**SUBJECT:** Modification to induction air filter can/inlet air assembly and addition of baffle support.

**MODEL/S/N AFFECTED:** MOONEY M20M, Mooney TLS, S/N 27-0001 thru 27-0011

FIGURE SI M20-87-1

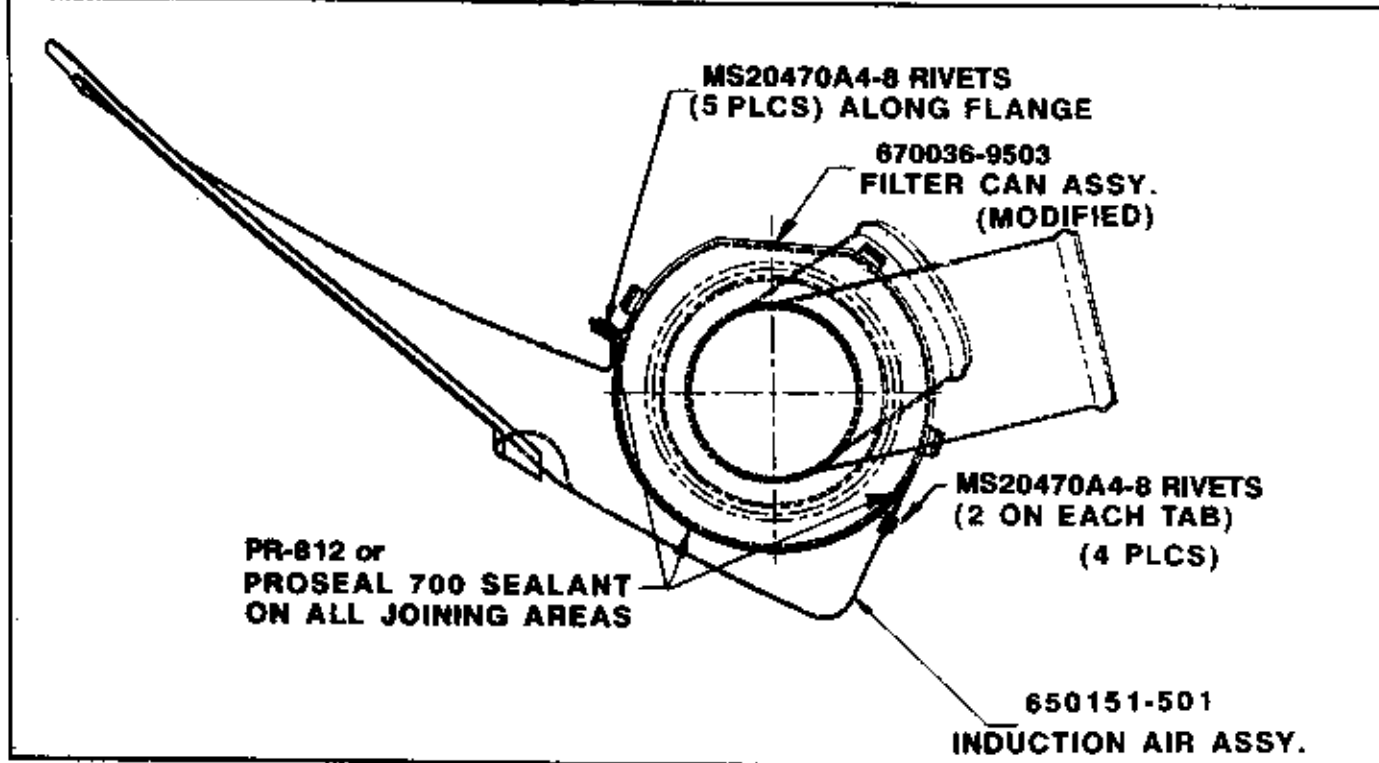
4. The 650151-501 fiberglass induction air assembly is to be modified as follows:
  - a. The aft flange (the one that has a joggle (break) from the center area to one end) is to be cut off and ground smooth, back to the wall of the fiberglass duct. This should be done carefully to ensure a smooth top edge for mating to the modified aluminum filter can assembly (SEE FIGURE SI M20-87-1).

9. Reposition components and securely rivet filter can assembly and induction air assembly together using soft MS20470A4 rivets (9 places) included in kit (SEE FIGURE SI M20-87-1).

FIGURE SI M20-87-2

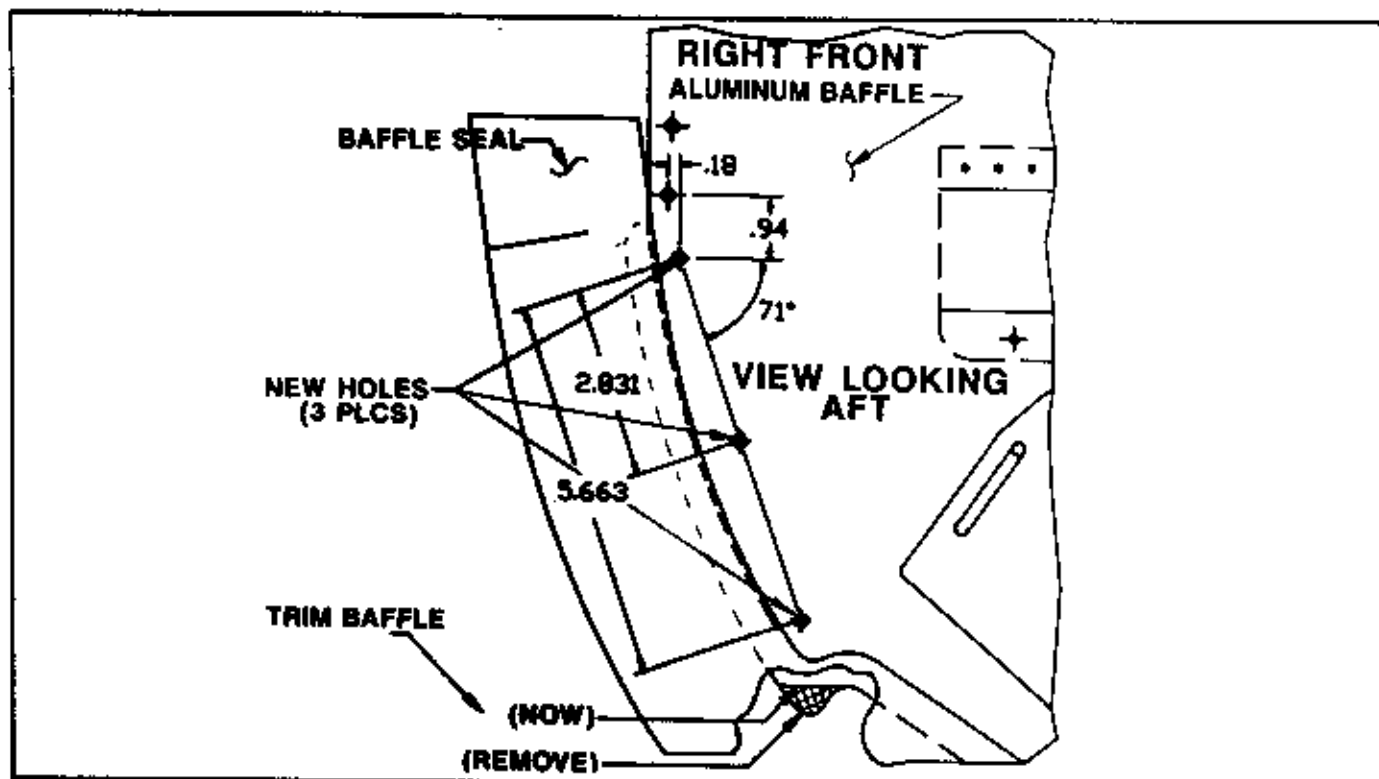
1. Drill three holes in right, vertical baffle (SEE FIGURE SI M20-87-2 for location of three new holes)., Use No.12 drill bit (.203 max. dia.).
2. Place 600425-059 support in position on right side of front, vertical and horizontal engine baffles (See FIGURE SI M20-87-3). Drill two holes in horizontal baffle using pilot holes in -059 support as guides.

3. Remove -059 support from baffle assemblies and deburr all mounting holes.
4. Refer to FIGURE SI M20-87-2 for modification of lower vertical baffle. Trim and smooth as shown to relieve any cowling interference.
5. Reposition support and attach to both baffles using MS51958-63 screws, AN960-10 washers, and MS 21045L3 nuts (5 places).
